**STAFF REPORT TO THE
FAIRFIELD TOWNSHIP ZONING COMMISSION
MEETING DATE: June 16, 2021**

CASE:	FTZC21-3C
APPLICANT:	NVR, Inc.
LOCATION:	Hamilton-Middletown Road (S.R 4) A0300-023-000-066, A0300-023-000- 063, A0300-023-000-083
CURRENTLY ZONED:	B-2 General Business District
REQUEST:	Zone change from B-2 to R-PUD- Residential Planned Unit Development District

PRELIMINARY PUD PLAN
WALDEN SPRINGS
SECTION 21, TOWN 2, RANGE 3
FAIRFIELD TOWNSHIP
BUTLER COUNTY, OHIO
MAY, 2021

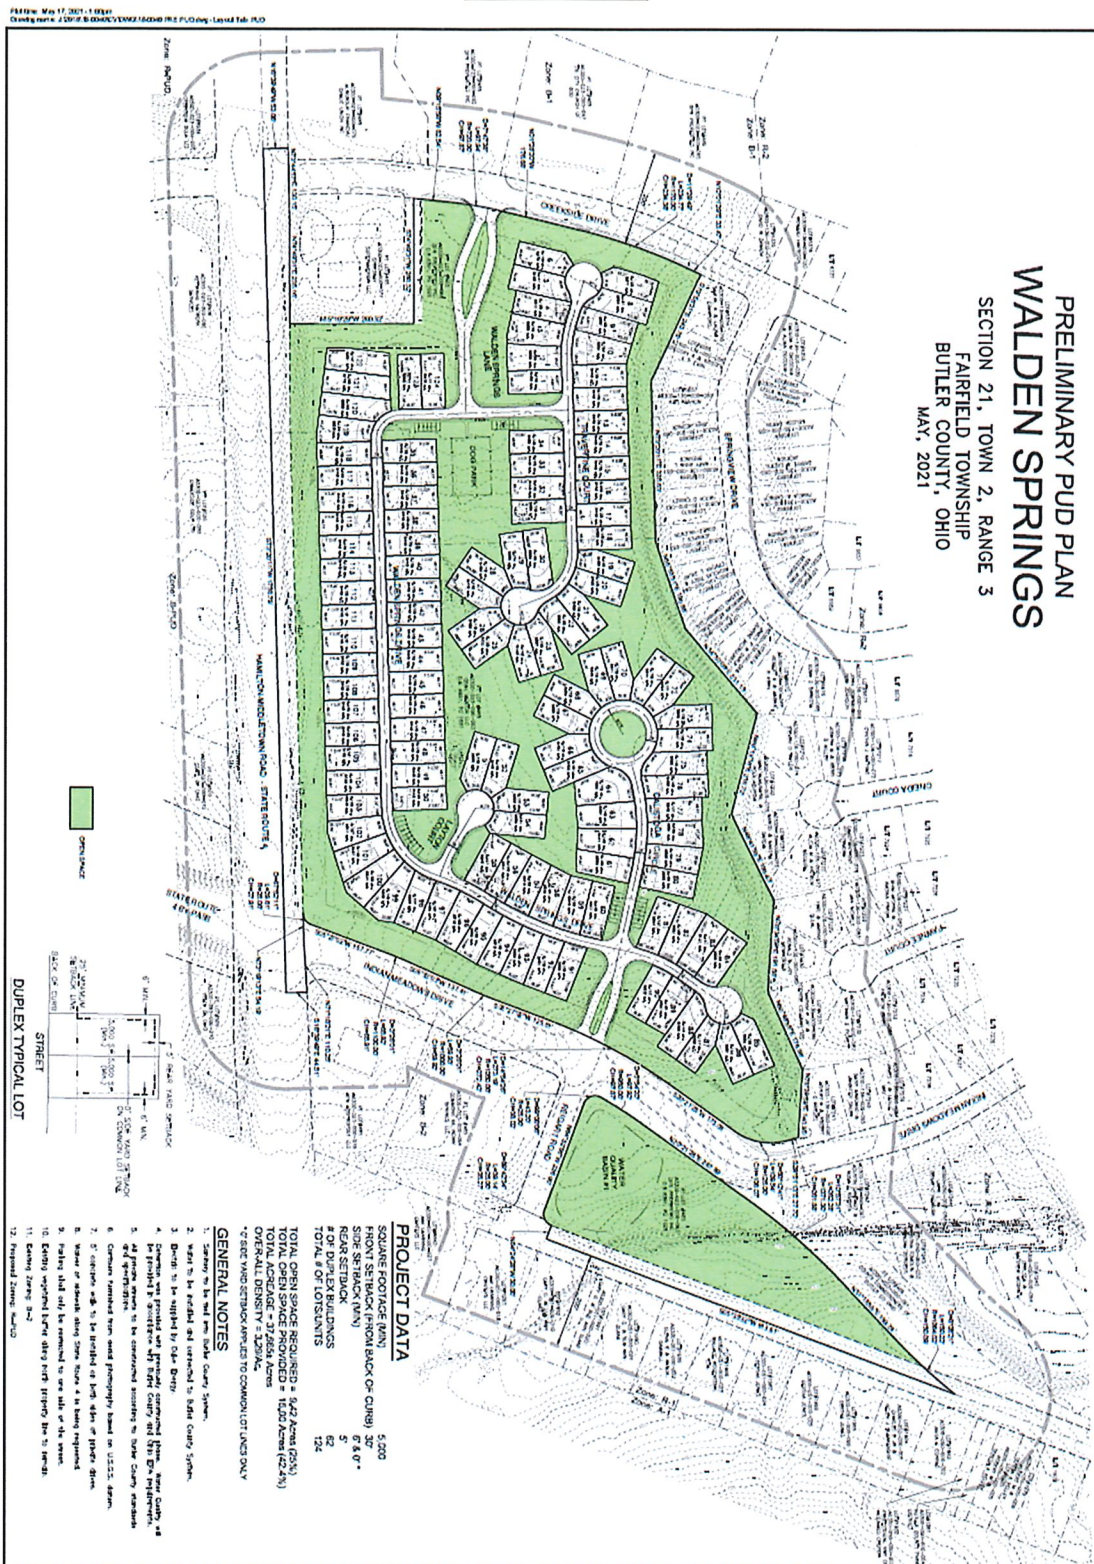
1. Walden Springs Drive & Lane should be constructed 28-ft in width. Travertine & Layton Court, Calistoga Circle and north end of Walden Springs Drive/Court can be constructed at 25-ft AND restrict parking on side of street containing watermain.

2. Lots 121 and 122 do not have road frontage.
3. Provide sidewalks along Indian Meadows Drive and Reigart Road on open space parcel.
4. Provide internal pedestrian connection between Travertine and Calistoga.

5. What landscape plans are envisioned for open space along Reigart Road? Will this lot be maintained by the HOA?
6. Comply with Ohio Environmental Protection Agency (OEPA) National Pollutant Discharge Elimination System (NPDES) Permit for Storm Water Discharges Associated with Construction Activity.

7. Submit a preliminary drainage report per Section 4.07 of the Subdivision Regulations.
8. Need to abandon any existing septic tanks with permits and inspections from Health District. Any existing private water wells need to be abandoned by a private water contractor with Health District inspections.

9. Note the HUC 12 Receiving waters on plat.
10. Plat will need basement note-> high water table.
11. Extend sewer to upstream boundary to Reigart Rd, across water quality basin property.

12. 30' san sewer easement required on lot fronting Reigart Rd.

Based on the staffs review of the submitted plans, it appears that the applicant's proposal has taken surrounding property owners' feedback and concerns into consideration. The plan's inclusion of a 50' buffer along the existing development to the north is an example of that. To further protect the value and safety of future residents, staff would like to see the existing vegetation along Hamilton-Middletown Road be removed and replaced with an HOA maintained vegetated buffer/berm/fence combination. Staff would also like to see sidewalks continued on both sides of Indian Meadows drive and along the roads that abut the water quality basin parcel. Township staff would also like to see some a landscape plan to improve aesthetics for the area around the water quality basin, also to be maintained by the HOA. To further embrace the intent of the Fairfield Township Vision Plan, staff would also like to see an increase of active open space within the development. One major point of concern mentioned by Butler County pointed had to do with the proposed 24' wide private roads within the development. County Staff stated that the roads should be constructed "28-ft in width. Travertine & Layton Court, Calistoga Circle and north end of Walden Springs Drive/Court can be constructed at 25-ft AND restrict parking on side of street containing watermain." The township is concerned with how this may impact access for emergency vehicles.

1. Incorporate comments submitted by the Butler County Planning Commission.
2. Walden Springs Drive & Lane should be constructed 28-ft in width. Travertine & Layton Court, Calistoga Circle and north end of Walden Springs Drive/Court can be constructed at 25-ft AND restrict parking on side of street containing watermain.

3. Remove existing scrub and deciduous vegetation along Route 4 and replace with HOA maintained berm and evergreen buffer to provide a visual and sound buffer from Rt. 4.

4. Continue sidewalks on east side of Indian Meadows Drive and connect to existing sidewalk.
5. Continue sidewalk along Reigart Rd. near proposed Water Quality Basin #1

6. Enhance landscaping and aesthetics of the parcel where the proposed Water Quality Basin #1 is located.
7. Increase areas of active open space, parks, trails, gathering areas, ect. Add a connection from.

8. Turning radius in the development shall meet the fire vehicle specifications shown in attachment.
9. Utilize street trees within the development.
10. All utilities should be placed underground.

11. Hydrants should be installed with 5" Stortz Fittings instead of the Threaded connection on the steamer fitting
